METRO FLOOD DIVERSION AUTHORITY

Thursday, September 28, 2017

**METRO FLOOD DIVERSION AUTHORITY
AUGUST 24, 2017—3:30 PM**

Traffic Control Devices List

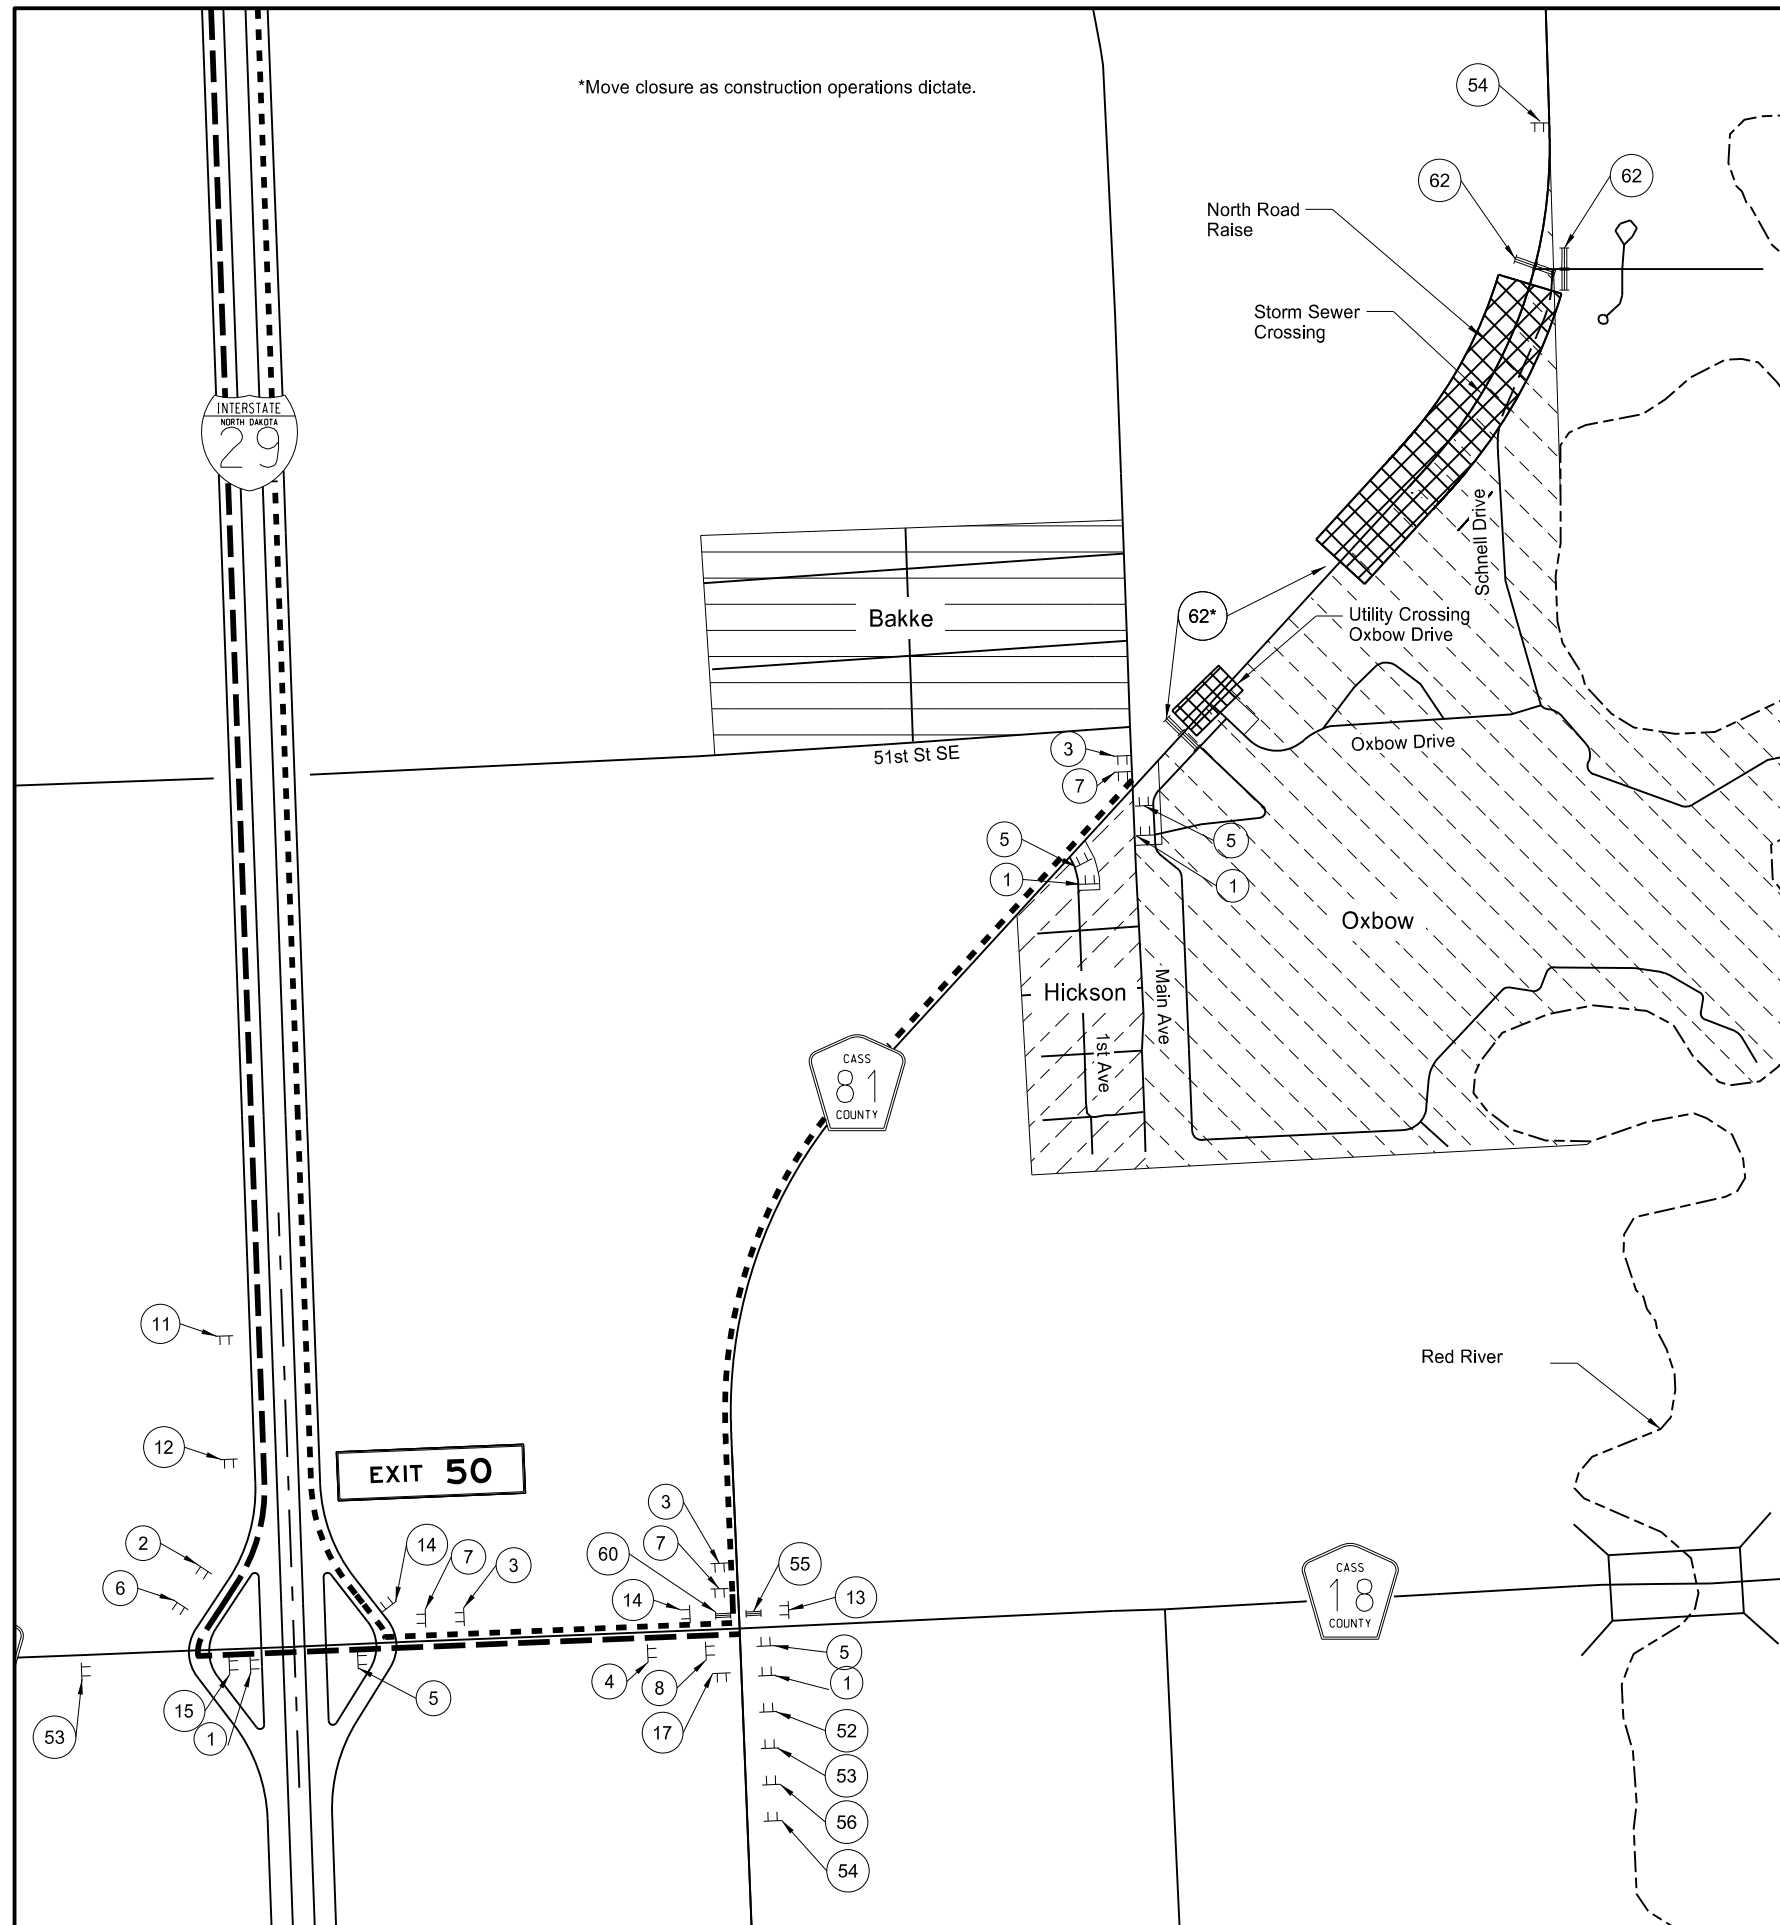
1. Revised R11-2-48 from 476 Units to 504 Units.
2. Revised R11-4a-60 from 93 Units to 155 Units.
3. Added SS1 for 40 Units.
4. Revised 704-1000 from 3923 Total Units to 4053 Total Units.
5. Revised 704-1052 from 23 EA to 27 EA.

1. Added Type III Barricades and Sign #62 on Paul Bunyan Drive.
2. Added a call showing the Type III Barricades and Sign #62 to be moved from the grade raise to South of Oxbow Drive work limits as contractor operations dictate.

1. Added SS1 as Sign #63.
2. Added requirements to cover a portion of the Existing Exit 54 Guide Signs (3 total signs).
3. Added requirements to cover the existing guide sign at CR 16 and CR 81 intersection.

OHB Levee
County Road 81
Utility Crossing/North Road Raise Detour

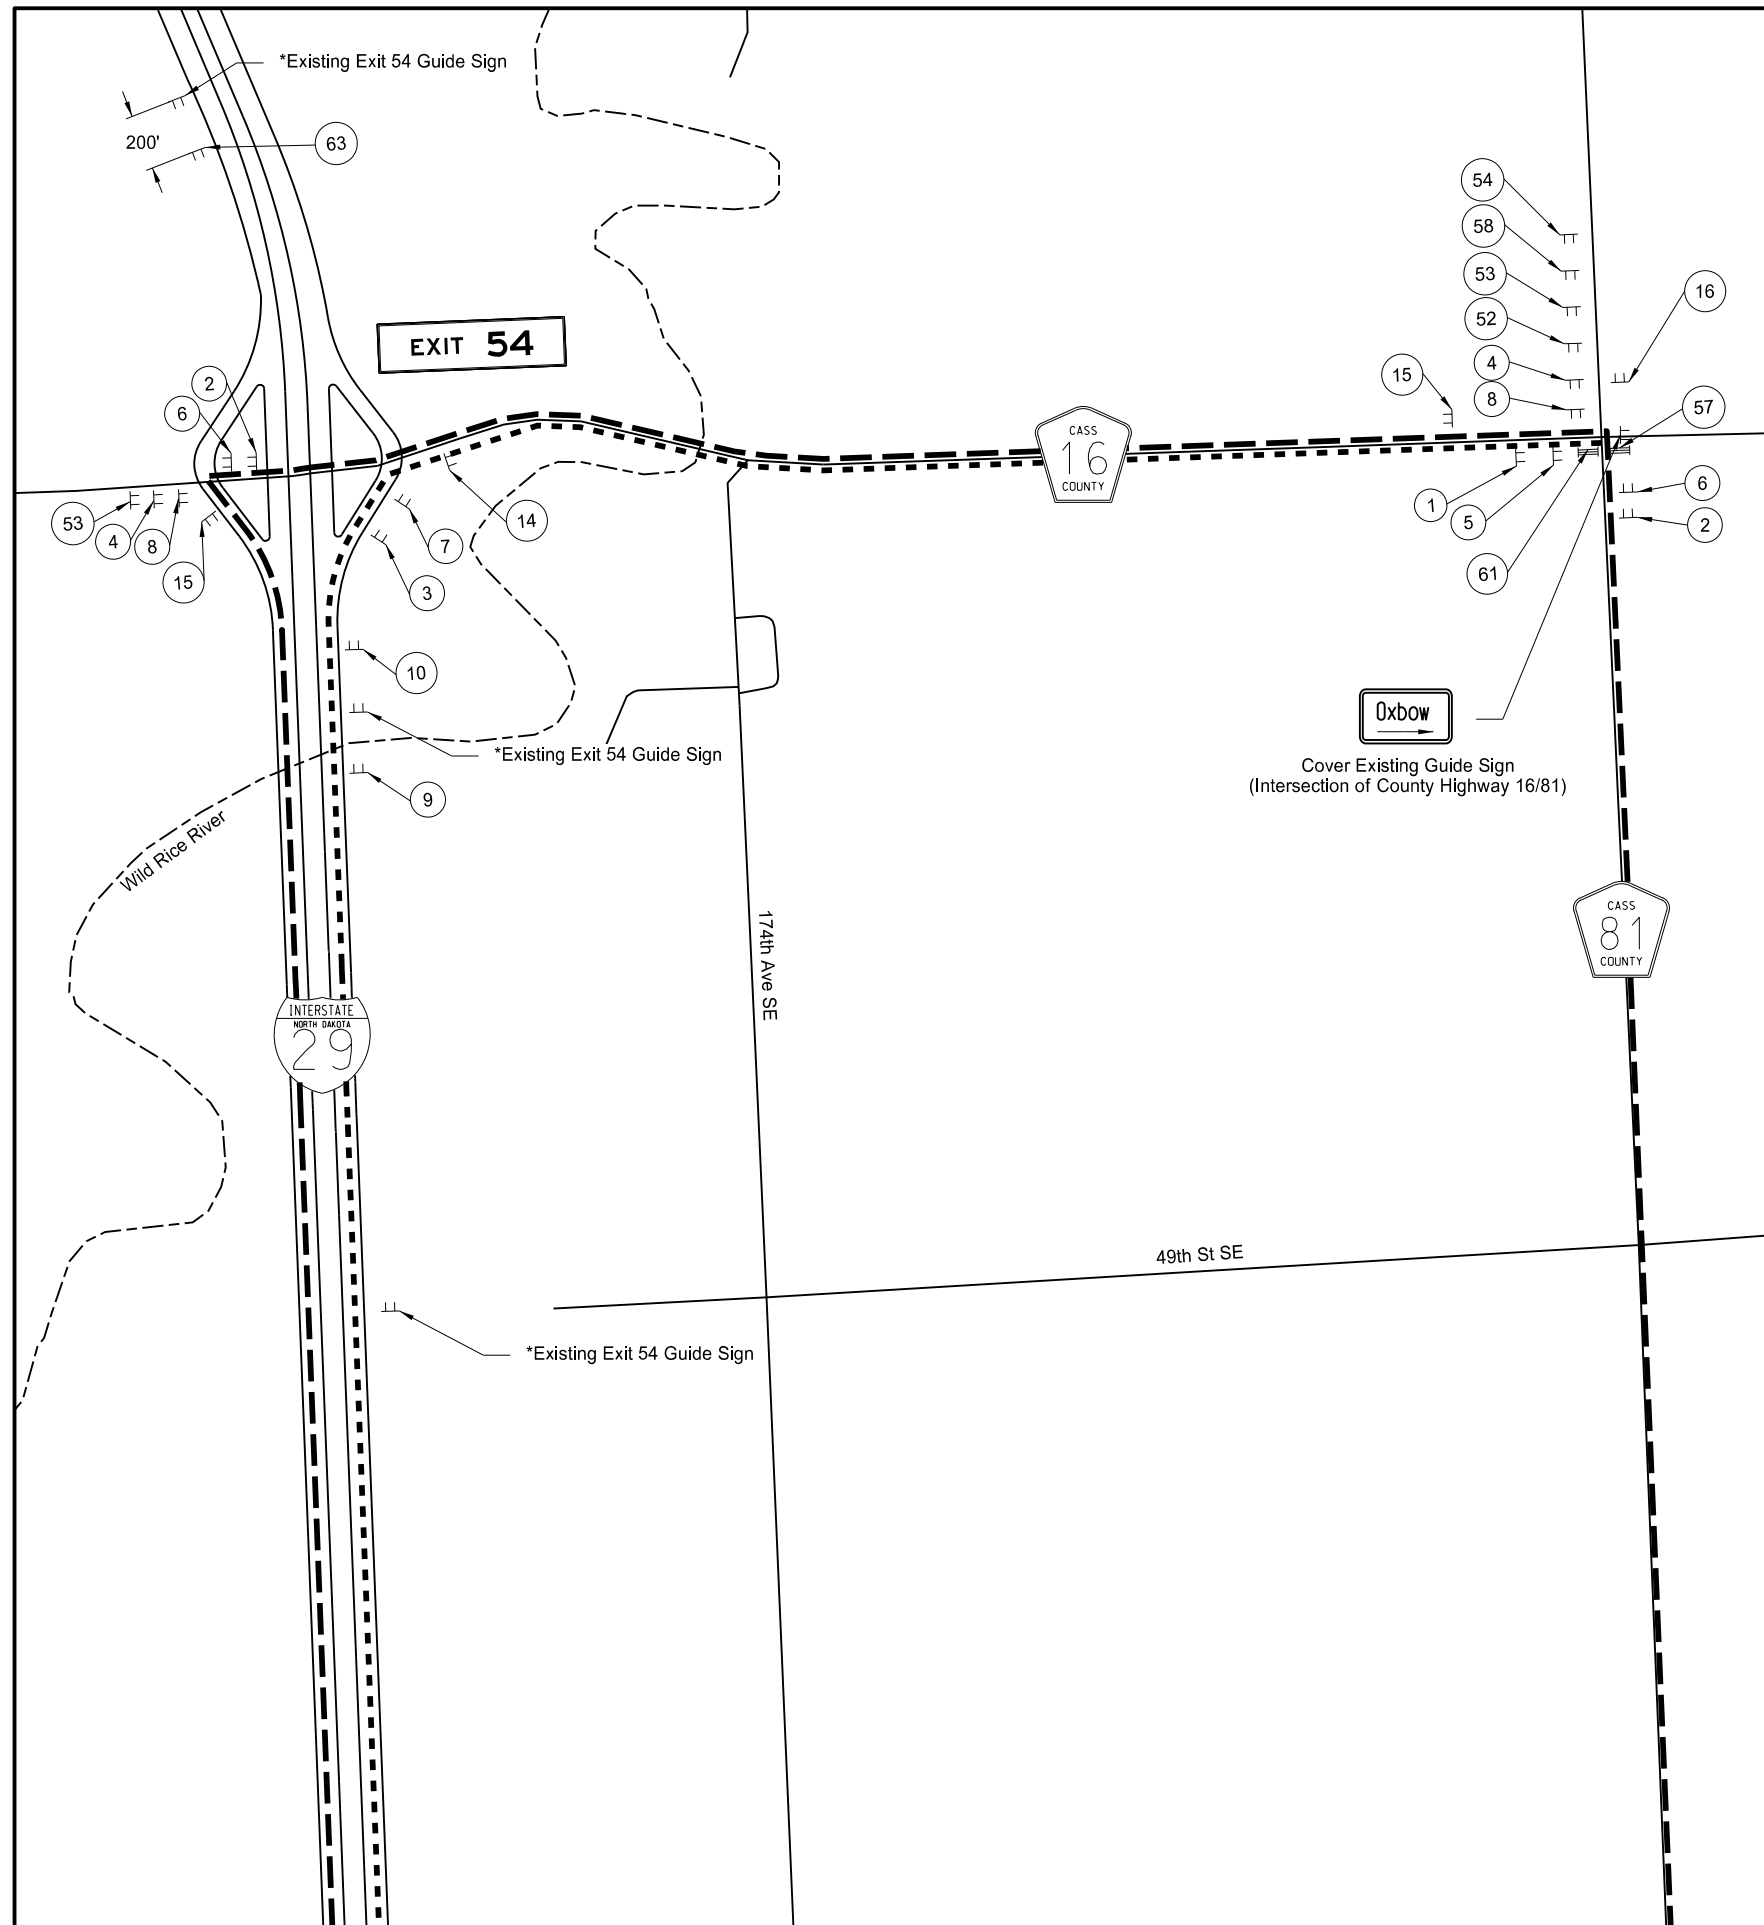
1. Added Construction Sign Detail Sheet for SS1.

4 SECTION: PIPE BEDDING - STEEL PIPE (DUAL GRAVITY DRAIN)
 CJ403 NOT TO SCALE
 STA 11+50 TO 14+00

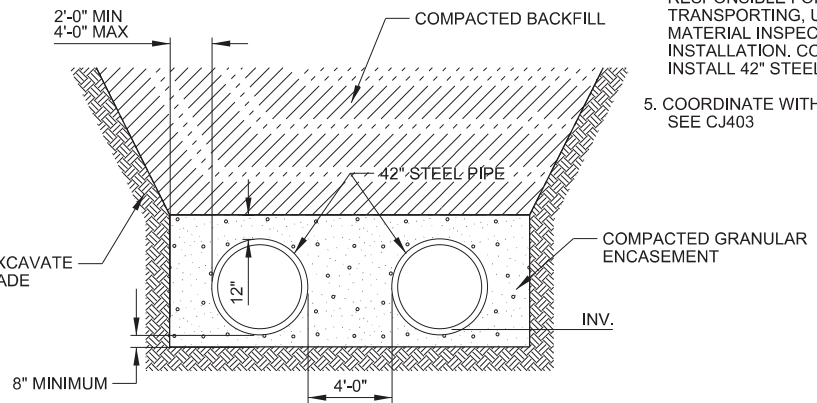
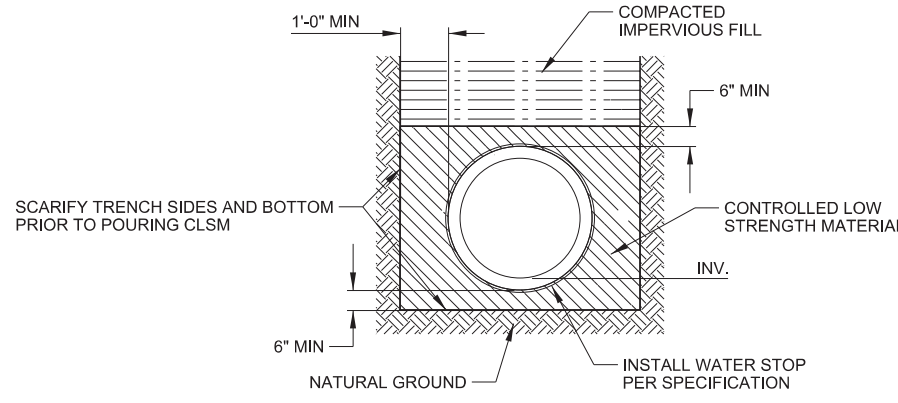
2. Increase 42-inch Steel Pipe Bedding, Backfill, and Time – The Contractor’s bid for 42-inch pipe excavation, bedding, and backfill was based on drawing CJ301/Detail 4, which showed the spacing between the pipes as 4’-0”. Drawing CJ502 shows the spacing between the pipes as 6’-10”. The Engineer of Record clarified in RFI FMDA-RST-000311 that the correct distance between the 42-inch pipes is 6’-10”. The additional 2’-10” width of excavation adds 275 tons of bedding material and 675 cubic yards of excavation and backfill. The time required to excavate and place the additional fill material is one (1) day.
 - a. CH2M and HMG have reviewed this cost and find it acceptable. The total cost for this change item is \$5,328.12.
 - b. CH2M and HMG have reviewed the additional time requested and find it acceptable.

The response to RFI FMDA-RSR-000311 modifies the Contract in that on Detail 4 on Sheet CJ301 the spacing is to be changed to 6' 10" between the dual steel pipes. As a result of this change, we will now be required to place an additional 2' 10" width of bedding in between the 42" steel pipes. Additionally, this change also increases the amount of excavation and backfill required for these pipes.

Description/Information Requested: Detail 4 on CJ301 shows 4'0" spacing between dual 42" steel pipe (dual gravity drain).
Details 1&3 on CJ502 show 6'10" spacing between dual 42" steel pipe (dual gravity drain).

Proposed Solution: Clarify if spacing between dual 42" steel pipes is to be 4'0" or 6'10".

The engineer changed the spacing between the pipe from 4'-0" to 6' 10". As a result of this change it requires the placement of an additional 2' 10" width of bedding in between the 42" steel pipes. Additionally, this change increases the excavation and backfill required for the pipes by 657 cubic yards. The time required to excavate and place the additional fill material is 1 day

Response: Spacing between dual 42" steel pipes is 6'-10"

For Detail 4 on CJ301, the 4'-0" spacing shall be revised to 6'-10"

FMM Diversion
Proposed County Road 16
Plan & Profile
Sta. 395+00 to Sta. 405+00

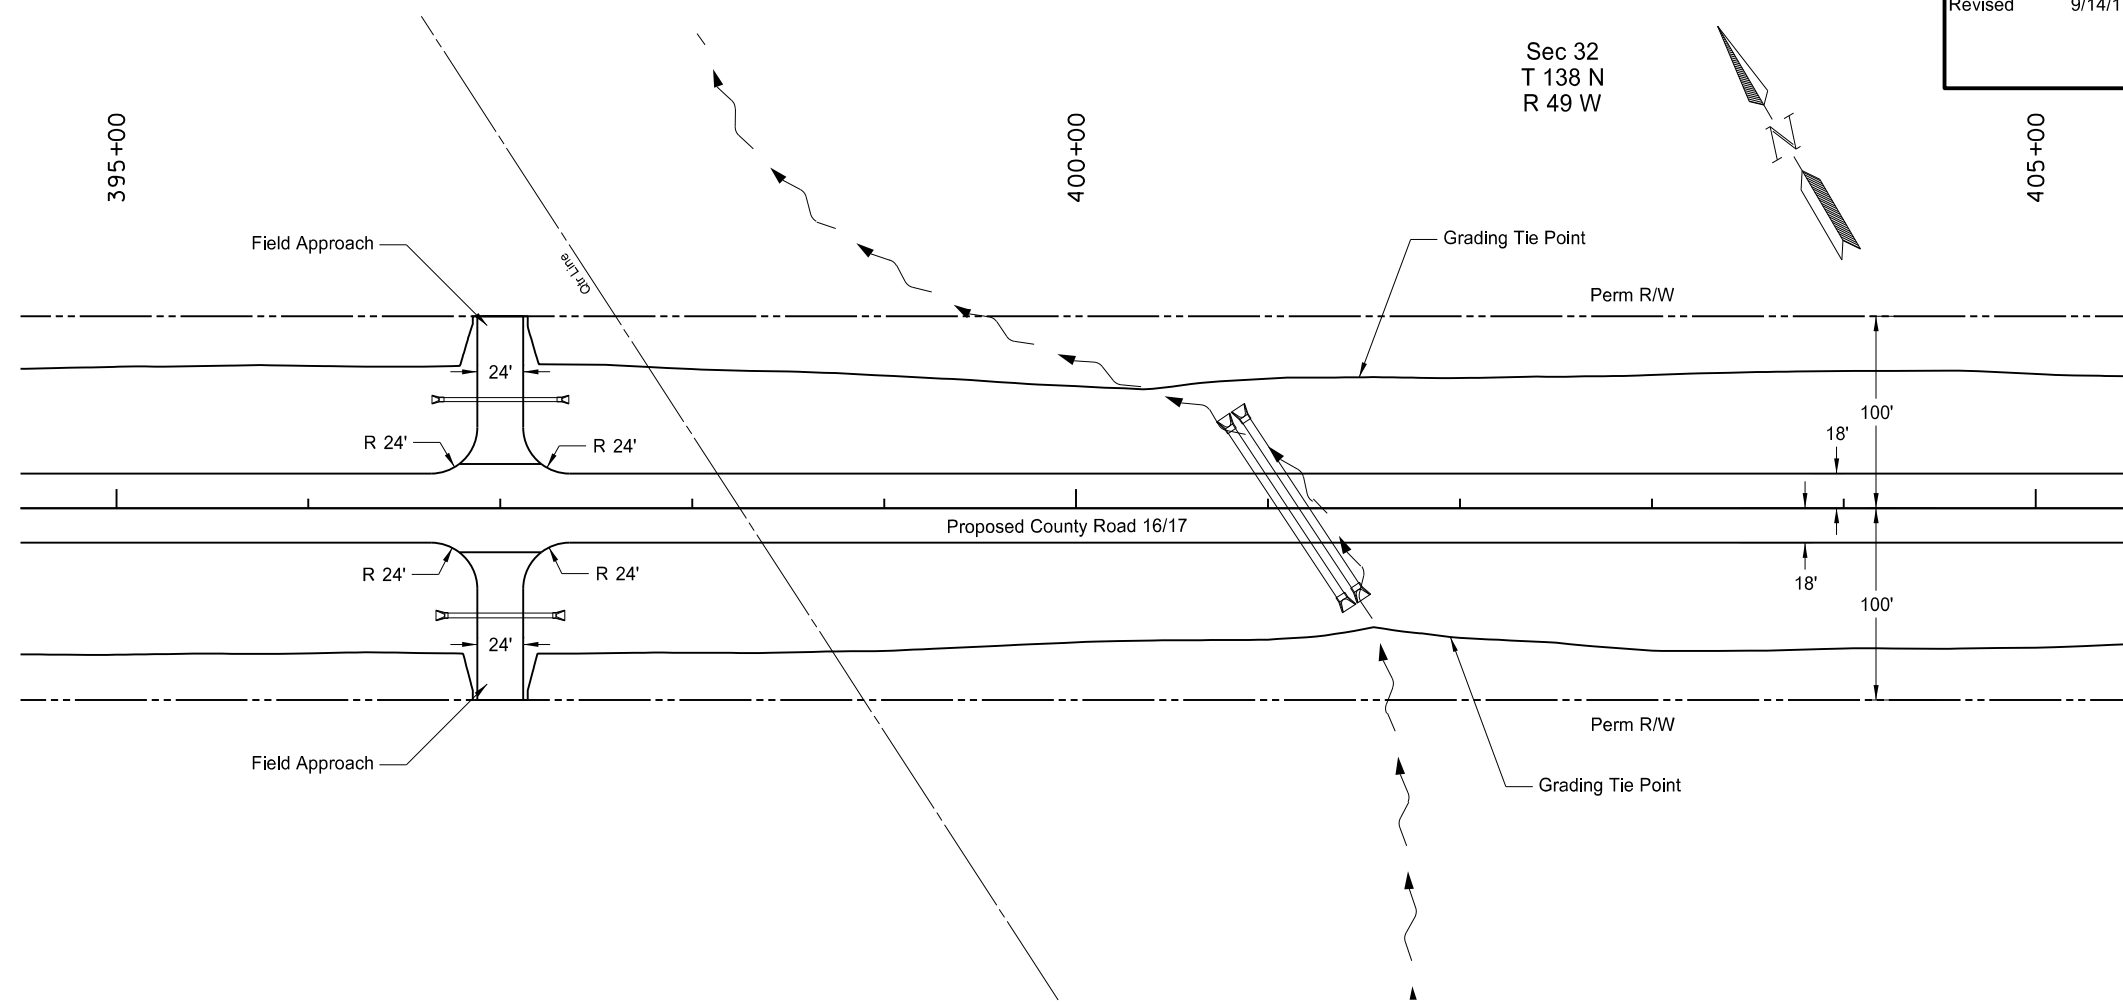
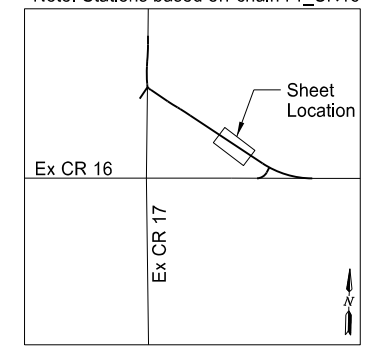
Adjacent landowners have expressed concern over the local drainage prior to the construction of the diversion channel. The drainage plan was reviewed and it meets current NDDOT Stream Water Crossing design standards. However, to match the end area of the upstream drainage structures and ease landowner concern, a second 54" culvert will be installed at Sta 401+19. In addition, the existing culverts north and south of County Road 16, crossing 57th St S will be left in place. These changes will be paid for at the unit prices bid for "202-0174, Removal of Pipe All Types and Sizes" (decrease) and "Pipe Conduit 54IN" (increase). The total cost for drainage modifications is \$21,655.84.

Adjacent landowners have expressed concern over the local drainage prior to the construction of the diversion channel. The drainage plan was reviewed and it meets current NDDOT Stream Water Crossing design standards. However, to match the end area of the upstream drainage structures and ease landowner concern, a second 54" culvert will be installed at Sta 401+19. In addition, the existing culverts north and south of County Road 16, crossing 57th St S will be left in place. These changes will be paid for at the unit prices bid for "202-0174, Removal of Pipe All Types and Sizes" and "714-4130 Pipe Conduit 54IN". The total cost for the drainage modifications is \$21,655.84. There is no schedule change associated with this change item.
